AGENDA

Development Commission

a) **PUBLIC HEARING: Issaquah Middle School Master Site Plan and Site Development Permit**

Subject: Briefing Memo regarding remanded issues for Issaquah Middle School, Master Site Plan, MSP 14-00002 and Site Development Permit, SDP14-00001

Figure 1.A. Elevations presented at the Development Commission public hearing

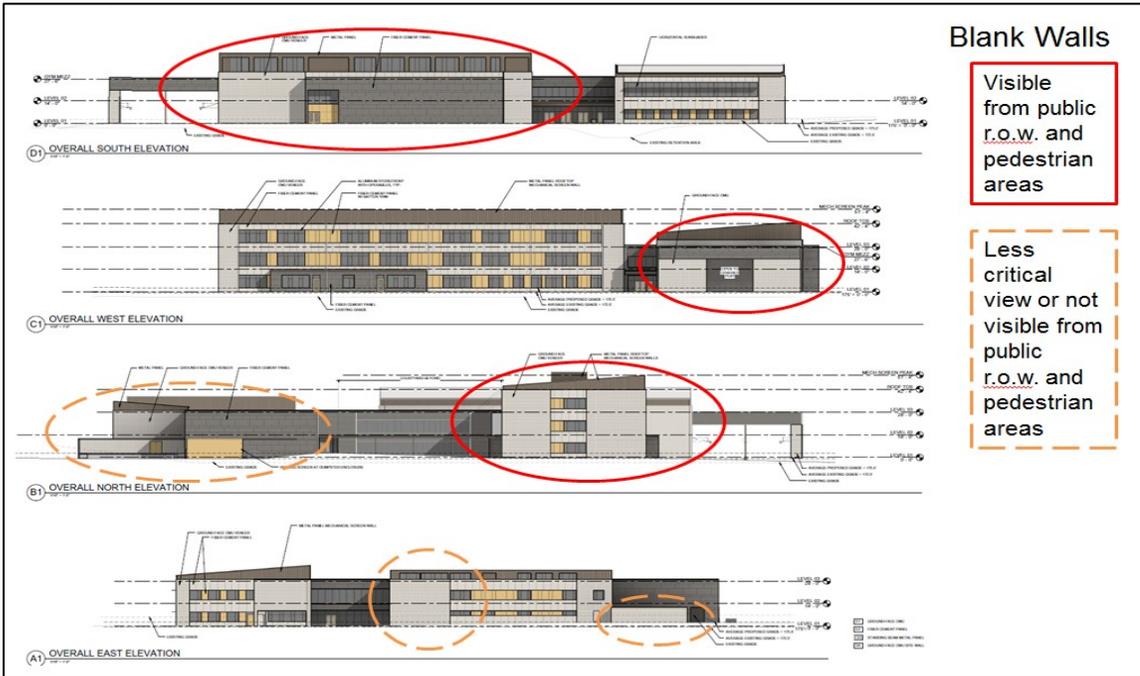
- On the north elevation, consider refining the widths of the walls to reflect the proportion used for the other facades, in particular, the Overall East Elevation, drawing A1. Given the strong asymmetrical roofline, the ribbon window section could be located off-center. Using the proportions of ribbon window and CMU wall widths of the other elevations as a guide, a narrower CMU wall could be aligned to the lower end of the roof, the ribbon window area expanded, and the wider CMU wall (approx. 2 times the width of the other wall) can be aligned to the taller end of the roof.

- On the east elevation, the blank wall of the servery shall be mitigated using windows, trellises, wall articulation, arcades, changes in materials, or other features. Acceptable alternatives include an herb garden or an art wall such as a permanent mural, sculpture or bas relief.

1. **South elevation**, blank wall at the Gym (Main entry): The applicant proposes to add a covered seating area expressed in the same color and materials as the main building.

4. **East Elevation**, blank wall at faculty lounge entry. This façade was greatly improved with the addition of windows. The loading dock, which has an 8-foot high screen wall facing the faculty parking lot will be softened with climbing vines (see Figure 1.C).

Figure 1.A depicts the elevations as shown at the Development Commission public hearing on February 18, 2015. Figure 1.B shows how the elevations have been revised to mitigate the blank walls. (Larger versions of the elevation drawings are provided as Exhibit No. 21)

Staff Recommendation: Condition addressed; therefore, delete Condition C.5.

Figure 2. Proposed new location of Rainier Trail presented at the Development Commission public hearing (drawing, not to scale)

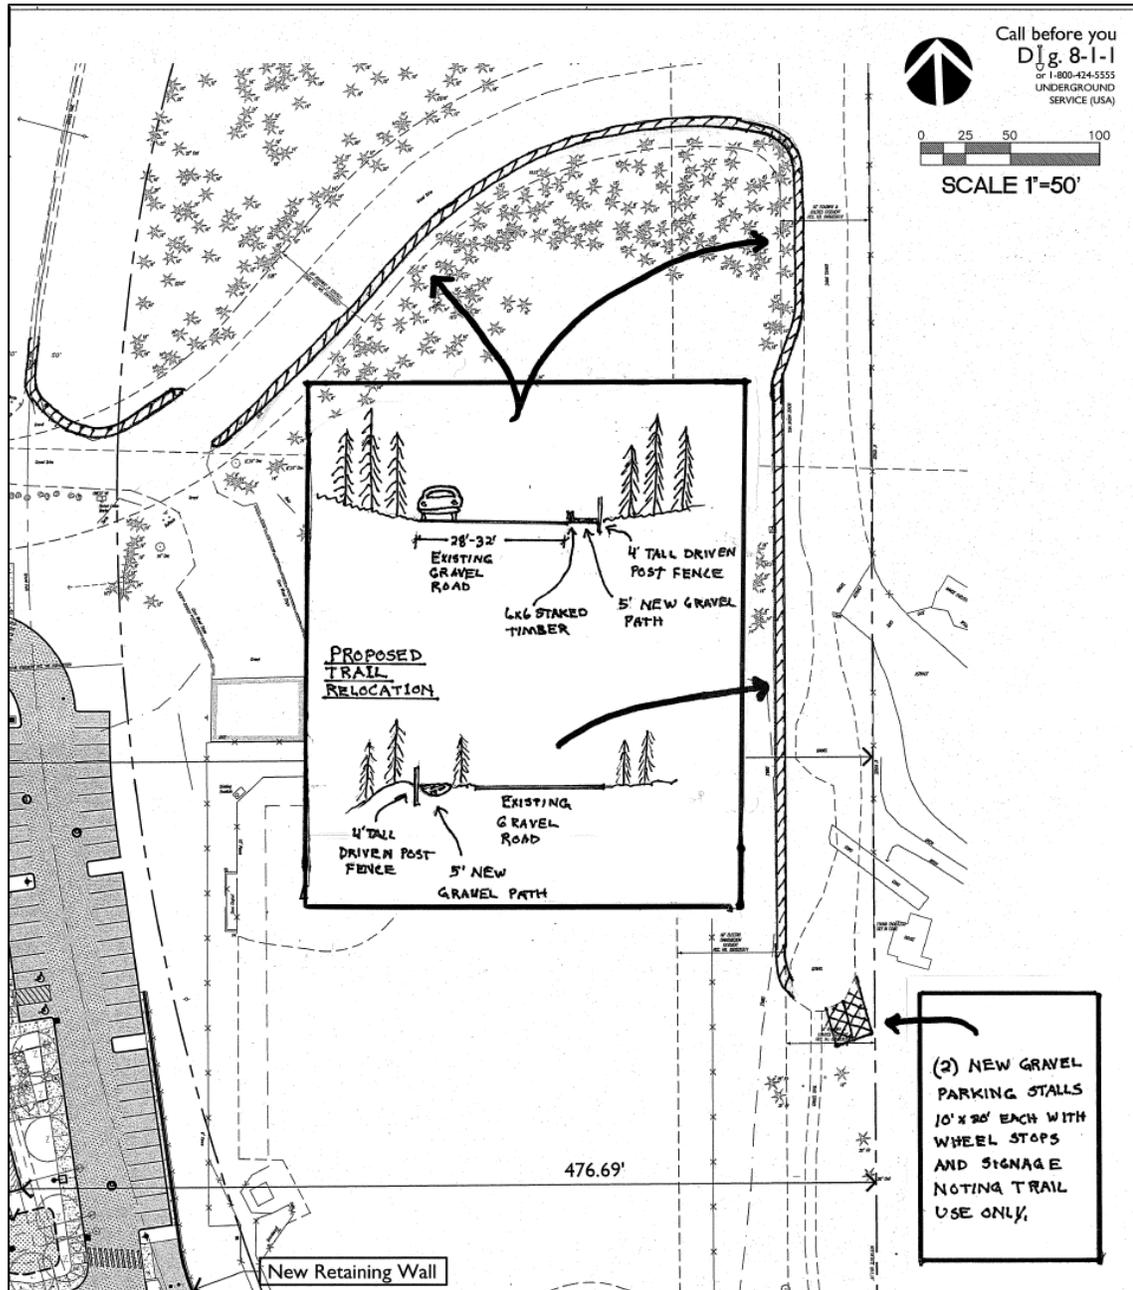
Findings of Fact: The Issaquah School District proposed relocating the existing eastern leg of the Rainier Trail to a location outside of the school property. Figure 2 below is the conceptual drawing of the trail relocation that was shown at the Development Commission meeting. At the public hearing, Staff questioned the proposed location of the crosswalk and the trail alignment. The condition of approval required the applicant to work with City Staff to identify the final alignment of the gravel path and additional parking for trail users along the access road.

As shown on Figure 2 below, the new trail is unchanged from the configuration presented to the Development Commission during the first public hearing: the trail will connect from an existing cul-de-sac that has a trailhead connecting to the Rainier Trail and the new trails in the Park Pointe conservation area. Two gravel parking spaces signed only for trail users will be provided near this access point. The relocated gravel trail will proceed northward along the western edge of the wooded area of the School District's property and turn west towards SE Evans. The trail will continue along the southern edge of the access drive to the Issaquah Sportsmen's Club and turn north to connect to the rest of the existing Rainier Trail. As part of the Development Commission's first public hearing, the permits were sent forward with the following recommended condition:

Condition D.9 (As revised by Development Commission): *The existing section of the Rainier Trail in the School District property will be replaced with a 6-foot wide gravel path, to be located from the point where the Trail forks, extending north up to the access road for the Issaquah Sportsmen's Club, then connecting back to the Rainier Trail north of the access road. Crosswalks will be provided where the trail crosses the access road. The applicant will work with City staff to identify final alignment of the gravel path and any additional parking for trail users along the access road. Final approval of the trail design by the City Parks and Recreation Department shall be required prior to approval of Site Work or Landscape Permit.*

Conclusion: Staff finds that the diagonal parking configuration solves the illegal parking problem on one side of the access drive. The width of the access drive can only accommodate the drive aisle and one row of diagonal parking, effectively prohibiting illegal parking. This reconfiguration also demarcates the edge of the trail with the use of wheel stops. The sketch of the proposed trail does not clearly show whether the trail will be within the 60-foot access easement. School District will need to provide public access at all times.

D.21. *The School District shall provide a 10-foot wide public access easement for the entire length of the new trail that is located outside of existing easements.*

D.23 *The trail width, design and paving materials shall be further reviewed when the School District submits an Administrative Site Development Permit for the development of a new high school parking at the northeast corner of the site, as shown in the plan set submitted on February 11, 2015, sheets G-004 and L-0001. A split rail fence for the trail, new sidewalks, and other pedestrian improvements to the parking lot shall be provided as part of the new parking lot and the final design of these elements shall be coordinated with the landscape edge improvements of the new high school parking lot.*

Figure 3.1. Diagram showing existing wetland buffer and extent of impacts and mitigation proposed by the Issaquah School District (drawing, not to scale)

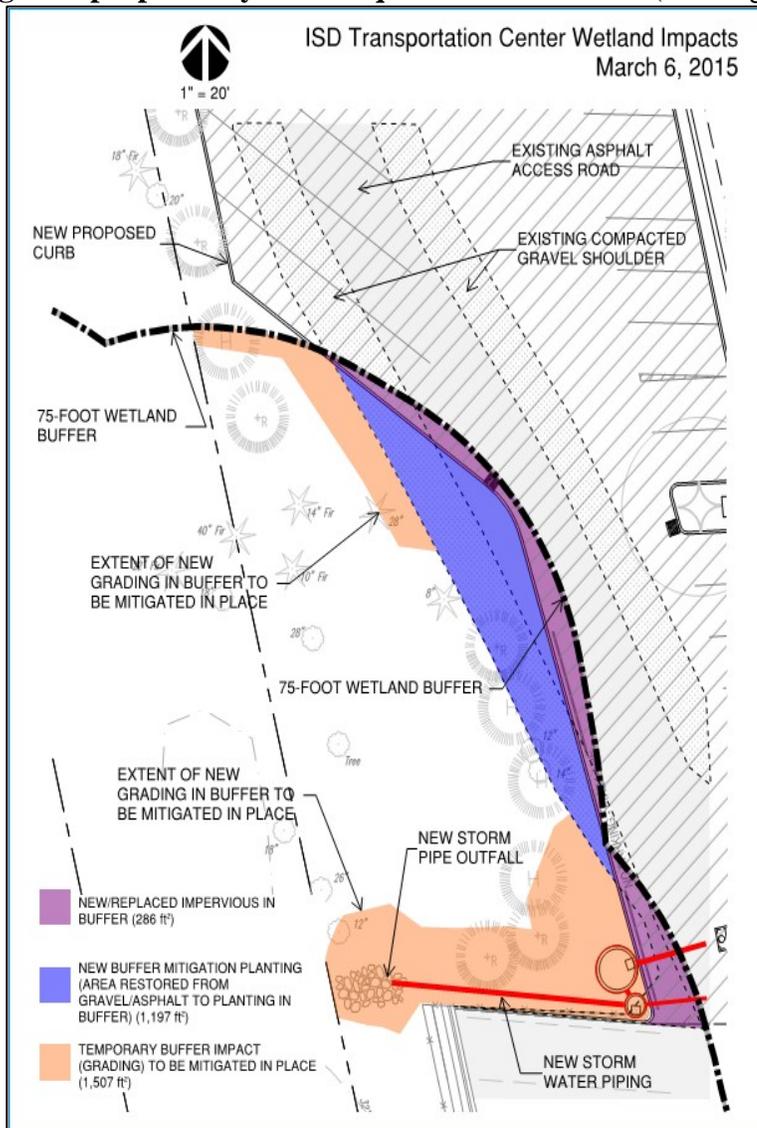
There will still be disturbance of approximately 1507 s.f. into the wetland buffer due to a new outfall (see Figure 3.1 below) which will be mitigated. The proposed outfall will convey stormwater from the bus yard into the buffer area. IMC 18.10.660.D. allows stormwater runoff to be discharged into wetland buffers, as long as it is treated. Furthermore, Section 18.10.610.B.4 , *Activities Allowed in Wetland Buffers*, provides for performance standards as follows:

Surface water discharge to a wetland from a detention facility, presettlement pond or other surface water management activity or facility may be allowed if the discharge enhances the wetland and/or does not increase the rate of flow, change the plant composition in a forested wetland, or decrease the water quality of the wetland.

- B.6 *In the Transportation Center, reduce the length of the stormwater pipe outfall so that there is adequate distance between the rock pad and the wetland. This area shall be enhanced with willow or dogwood stakes to slow the velocity of stormwater and provide uptake. Additional stakes could also be planted in the rock pad at the point of discharge.*

Figure 3.3. Details for the Proposed Wetland Mitigation at the School District Bus Yard (drawing, not to scale)

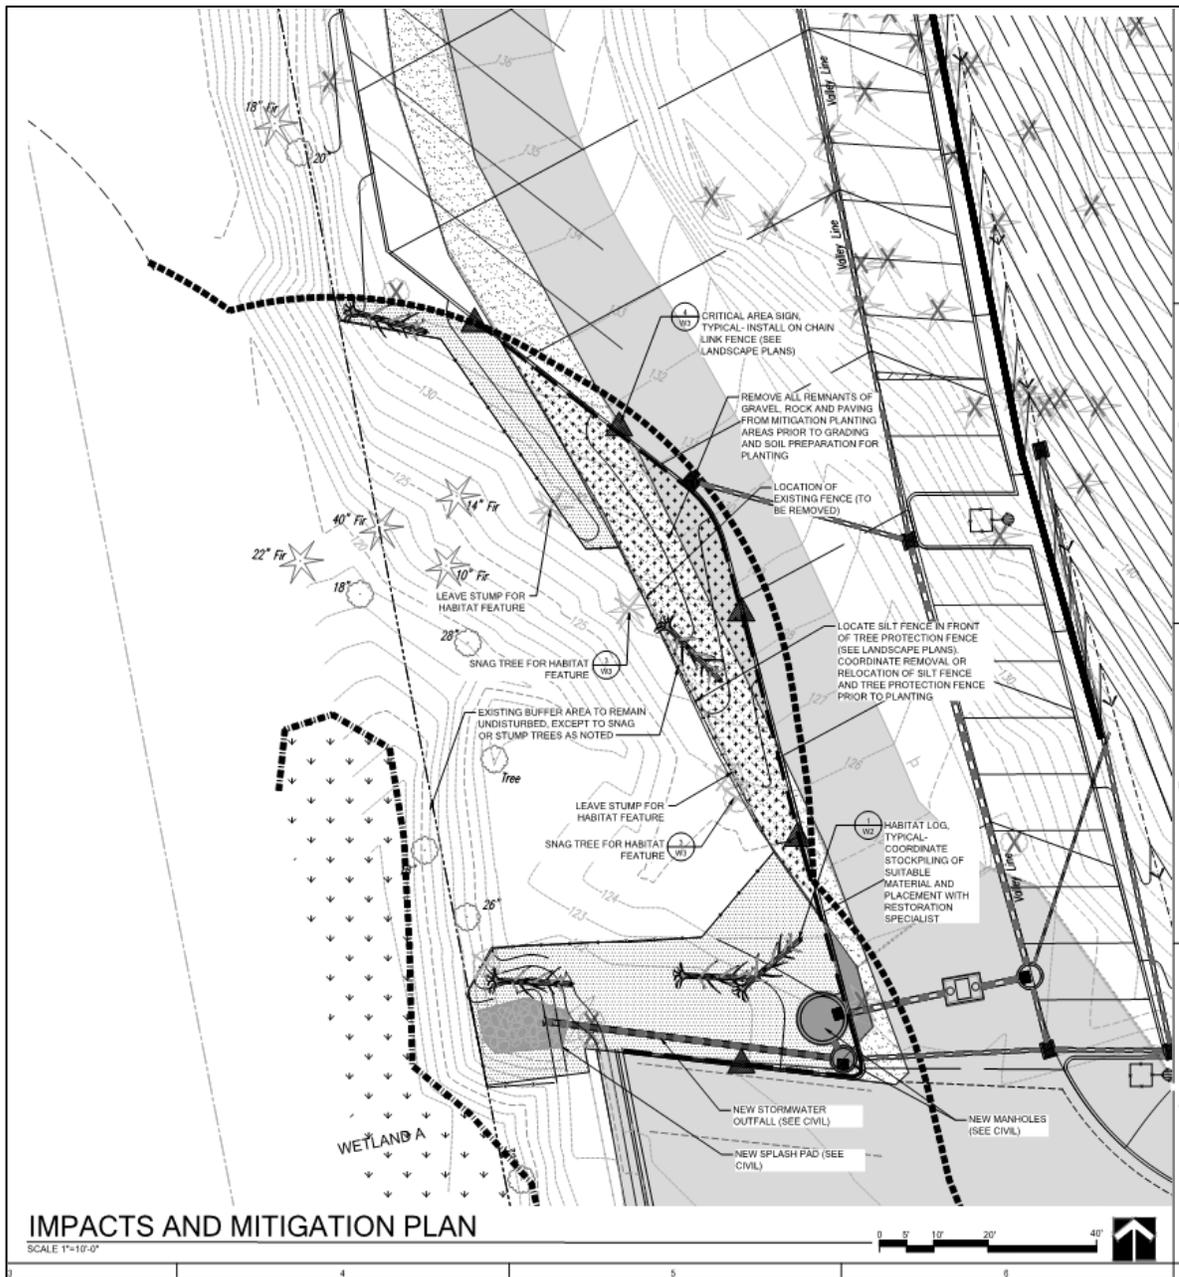
There will be a permanent impact to the wetland buffer of approximately 286 square feet, due to the paving of the edge of the expanded bus parking area. The School District is averaging the wetland buffer by replacing an existing gravel area, approximately 1200 square feet, with buffer plantings. Figure 3.3 shows the proposed mitigation and buffer enhancement provided by the School District’s wetland specialists. The School District has also updated the SEPA checklist to reflect the correct information (see Exhibit No. 22).

Conclusion: The School District submitted improved graphic information to accurately represent the proposed work in the wetland buffer, as well as the buffer areas that will be enhanced as part of the required mitigation. The proposed wetland mitigation is consistent with all code requirements for wetland buffer impacts, as provided in the Issaquah Municipal Code sections 18.10.720 to 760.
